**KNOXVILLE HISTORIC ZONING COMMISSION
STAFF REPORT - CERTIFICATE OF APPROPRIATENESS APPLICATION**

PROPERTY ADDRESS: 1237 Armstrong Ave 37917
DISTRICT: Old North Knoxville H-1

FILE NO.: 11-G-13-HZ

MEETING DATE: 11/21/2013

1237 Armstrong

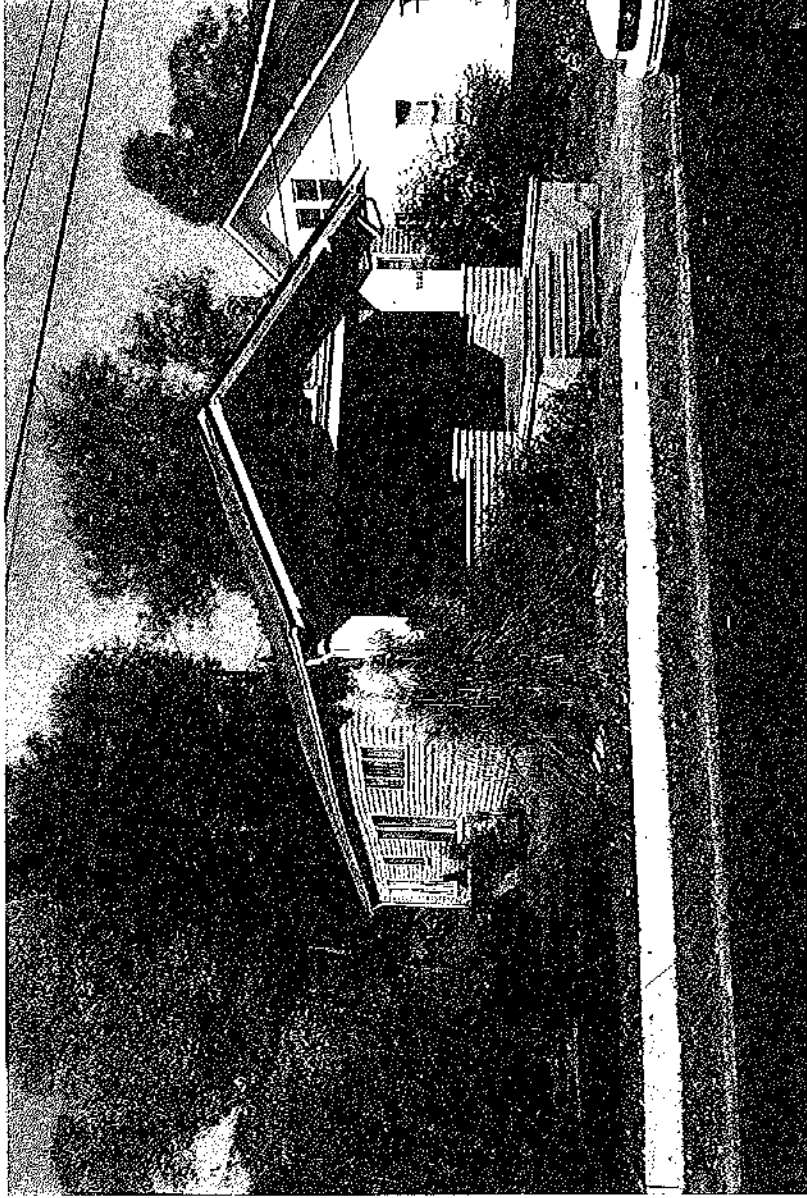
Window #1

Window #2

West Side

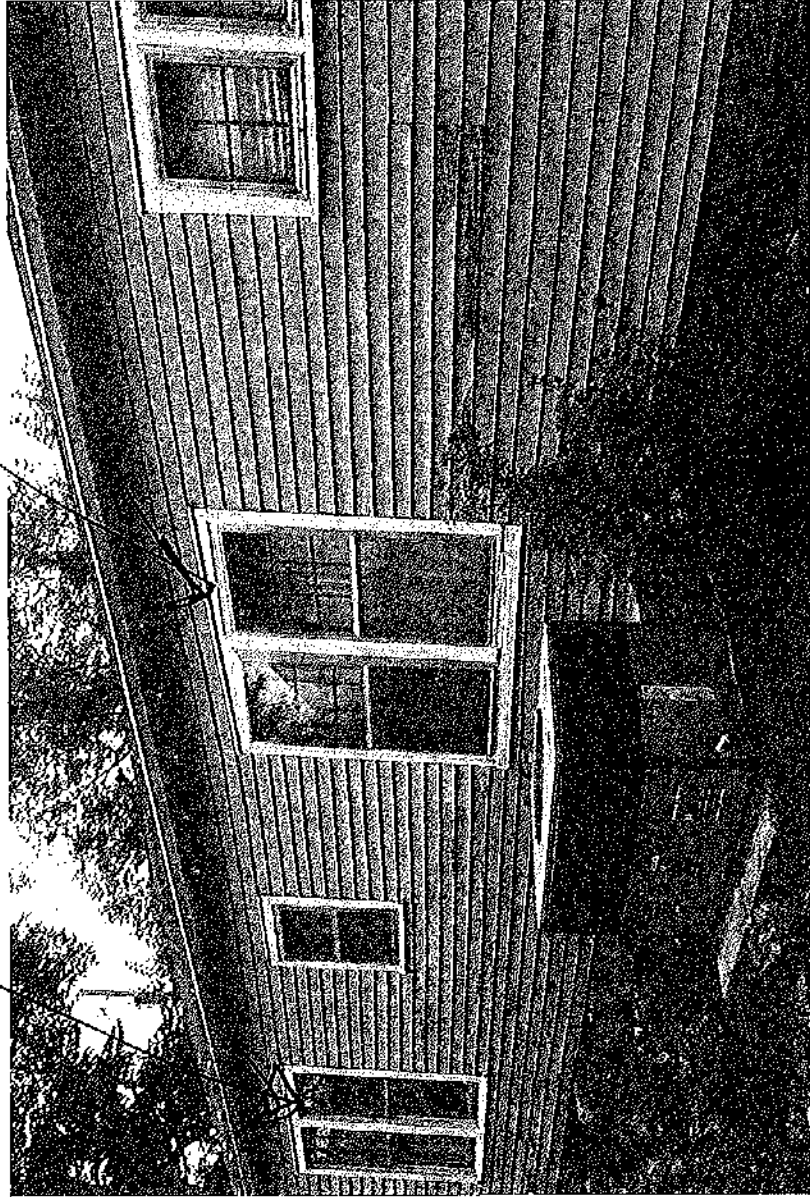
Window # 2

Replaced sill
with piece of

Window # 2

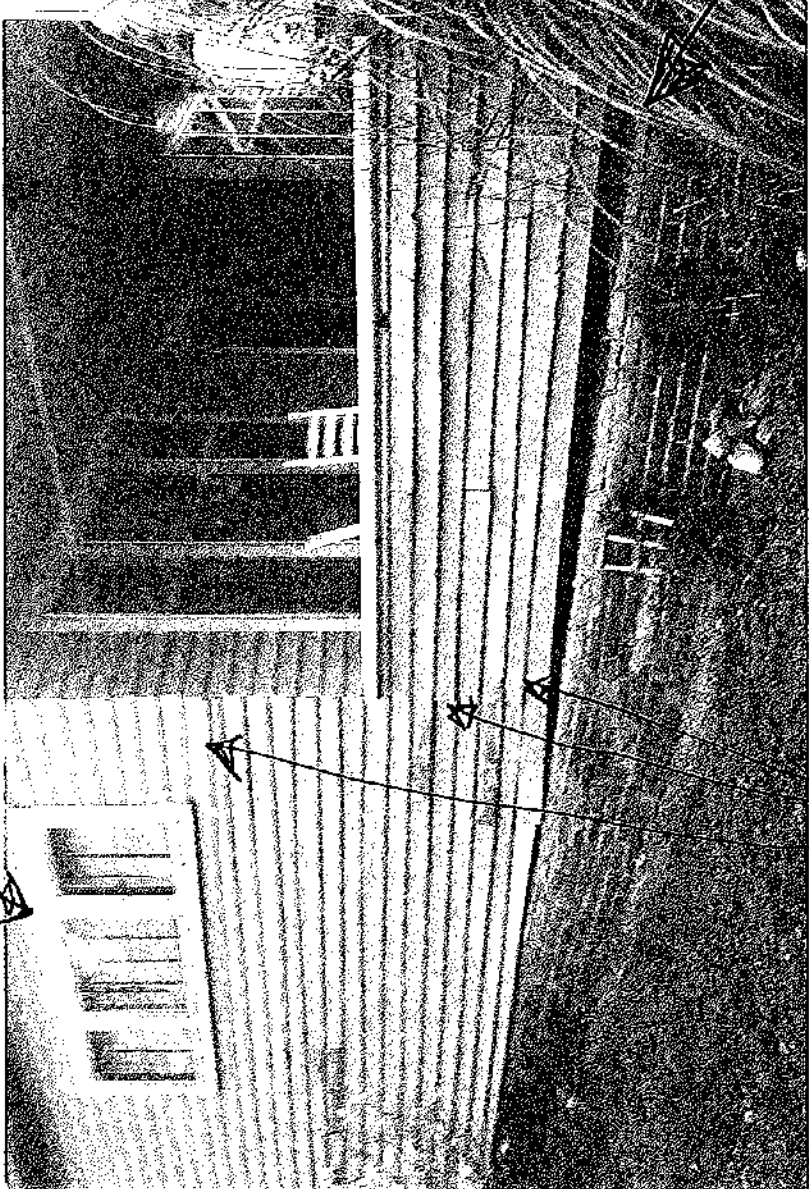
- ① Window out of square
- ② won't operate
- ③ Bottom sill is gone with
A piece of wood stuck
on it

Will save these windows

WEST SIDE

Setled Foundation

① WINDOW # 1

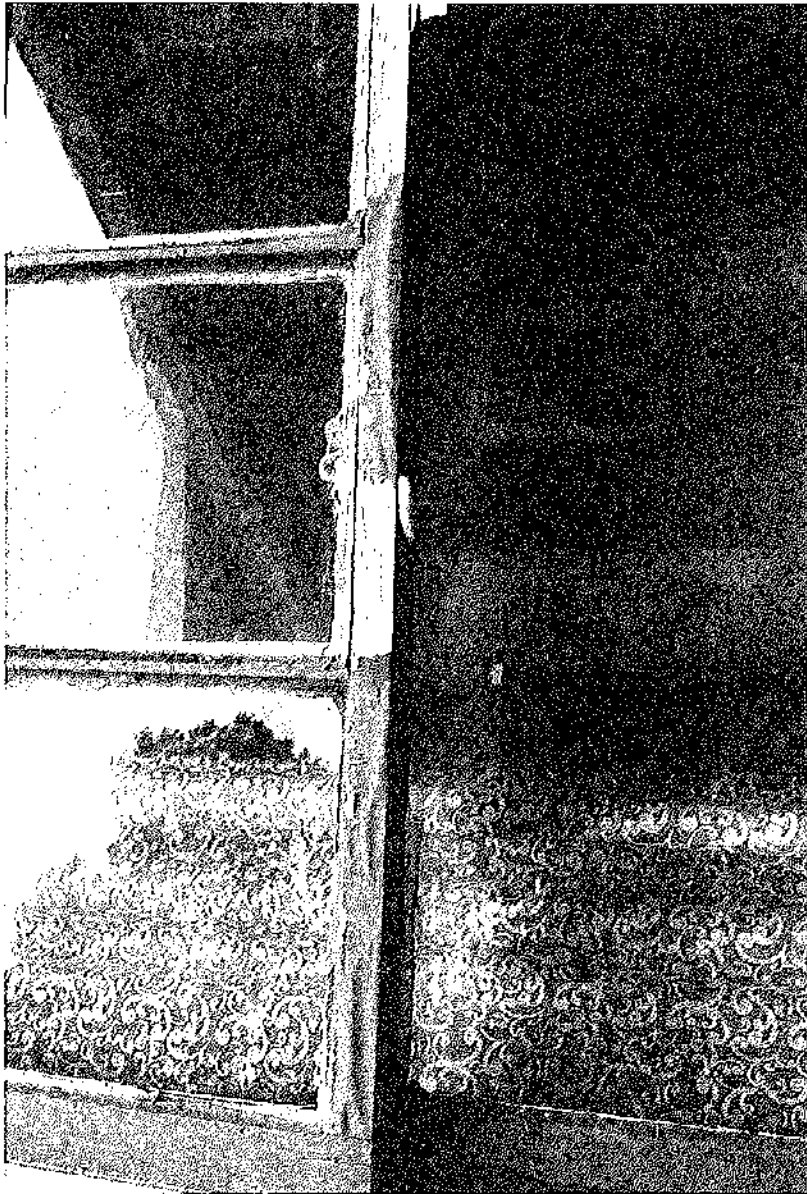
Popping Siding

REAR Windows on West
SIDE, Rotten window,
